# CITY PLANNING COMMISSION

- APPLICATION:
- A. Plan Review for a 30 unit apartment complex in the Garden Apartment-Review (R-2B-R) zone.
  - B. Lot Line Adjustment to merge two lots.

LOCATION: West side of Gloria Drive, 155+ feet south of Rivergate Way.

P87-047

SITE PLAN

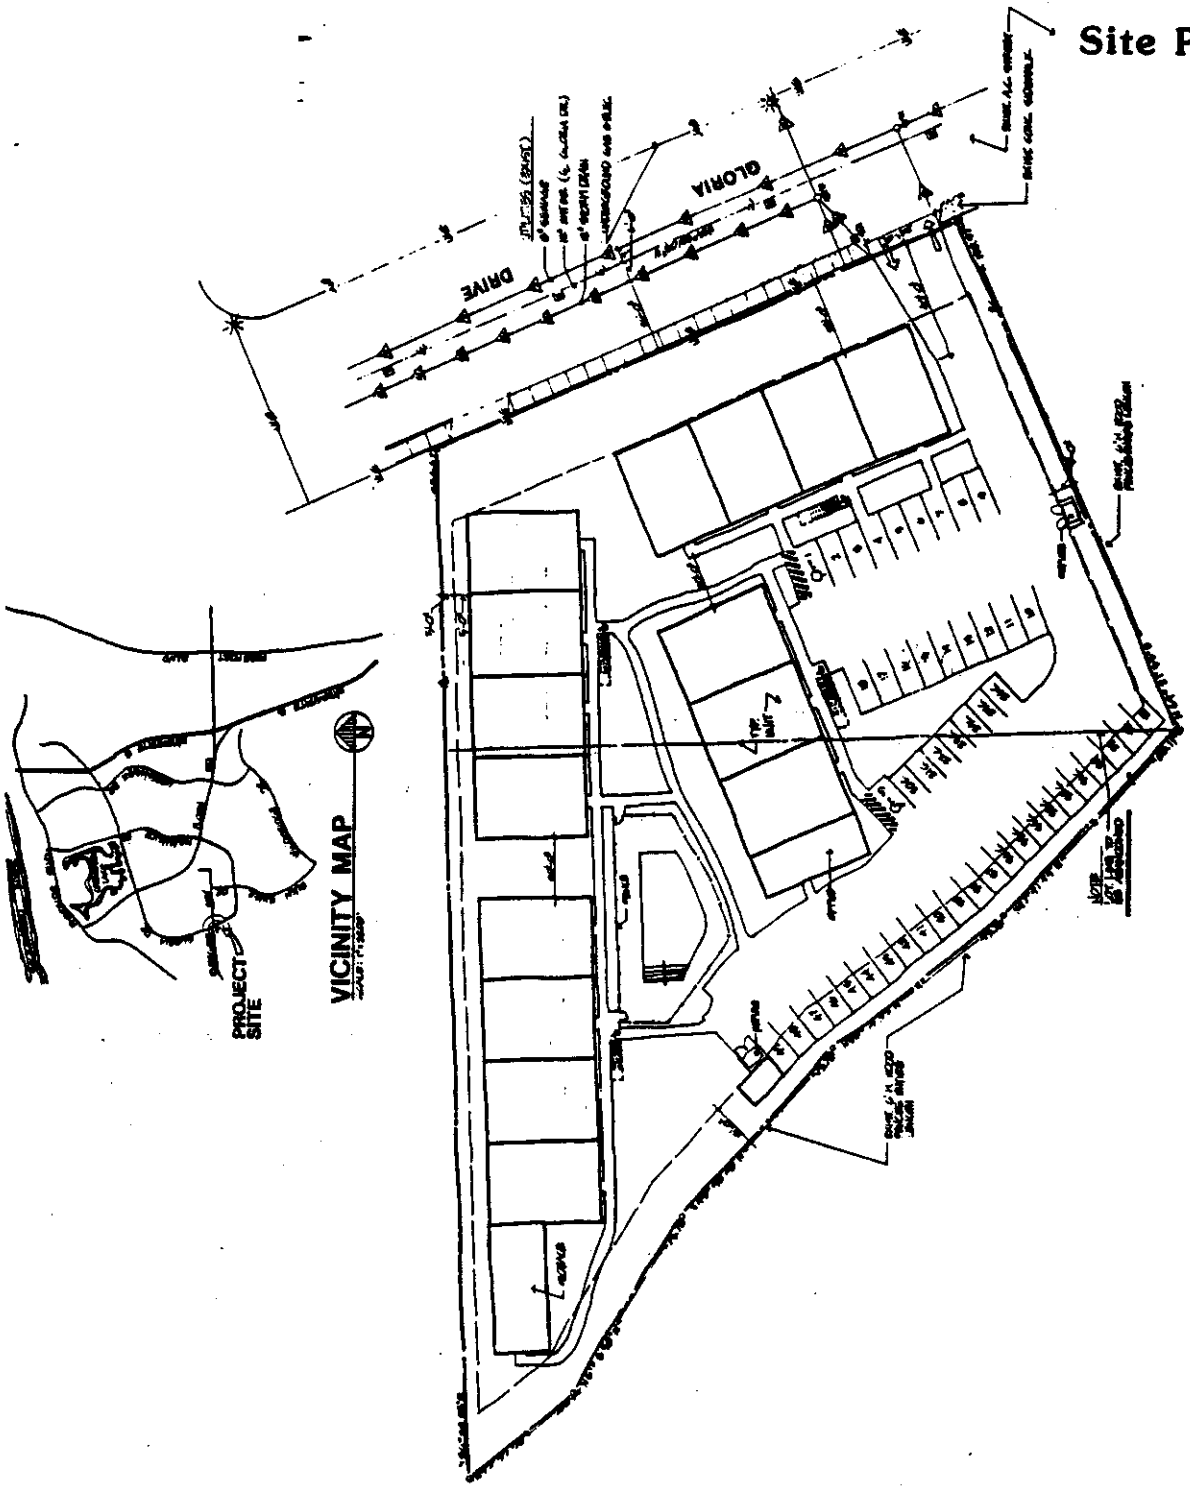
The applicant has designed the project so the proposed two story apartment buildings are located as far as possible from the adjacent single family residences. The closest two-story structure is 22 feet from a single family residential property line and a one-story storage building is 17 feet from a single family residential property line. Along the north property line, a 10 foot building setback is provided adjacent to the future apartment use. Staff finds the proposed building setbacks to be adequate. Staff recommends that all trash enclosures and pool equipment structures be setback a minimum of 15 feet from all property lines to provide a noise buffer for adjacent residences.

In order to provide an increased building setback from adjacent single family residences, a portion of the parking lots and driveway have been located adjacent to the south and west property lines. A minimum six foot high solid masonry wall will be required along the property line between the parking lot, driveway and adjacent single family residences. The applicant has also provided a six foot wide planter along the south and west property lines in order to plant trees to provide a noise and visual buffer between the apartments and the single family homes. Staff finds that the required wall and landscaping will provide an adequate buffer between the two uses.

A 25 foot setback is provided adjacent to Gloria Drive. Staff recommends that this area be landscaped with four foot high undulating berms with lawn and trees.

- a. A revised site plan indicating the relocation of trash enclosures and pool equipment structures setback minimum of 15 feet from all property lines shall be submitted for staff review and approval prior to issuance of building permits.

1. a minimum six foot wide landscaped strip between the south and west property lines and the driveway/parking lot area. This area shall be planted with minimum 15 gallon Evergreen trees and shrubs;

- c. A minimum six foot high, decorative, solid masonry, wall shall be provided along the south and west property lines adjacent to the driveway and parking stalls. The wall design and materials shall be subject to Planning Director review and approval prior to issuance of building permits. The design and materials of any other fences proposed along the north and west property lines shall be subject to Planning Staff review and approval.

EXHIBIT C  
 Floor Plan & Elevations

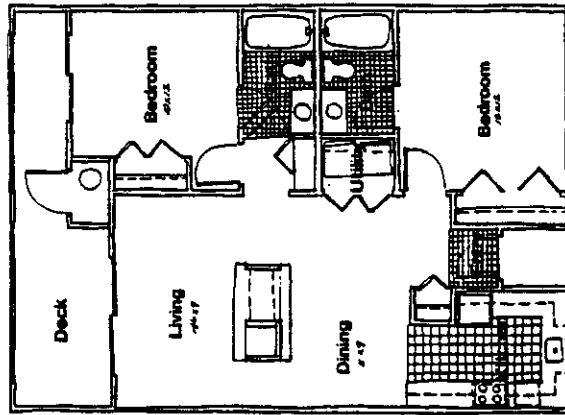
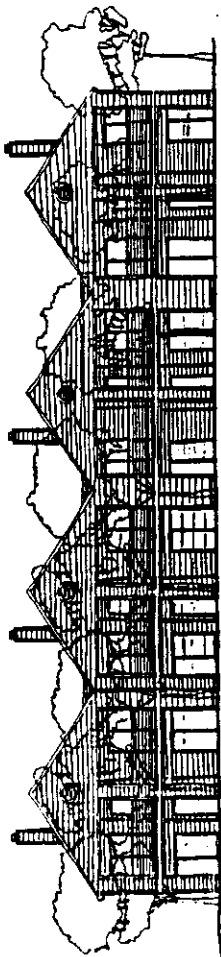
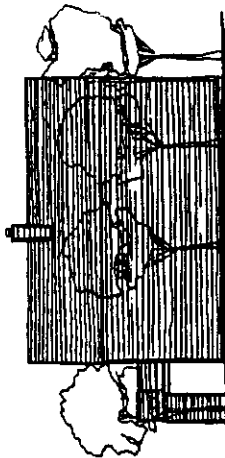
Overall, staff finds the proposed units to be attractively designed and compatible with the surrounding neighborhood. Staff does recommend, however, that the first and second floor patios be screened with a solid wall for security and aesthetic purposes. Staff also recommends that trees be planted adjacent to the end elevations to add visual interest to these otherwise solid walls.

- d. Revised elevations indicating screened patio areas shall be submitted for Planning Staff review and approval prior to issuance of building permits.
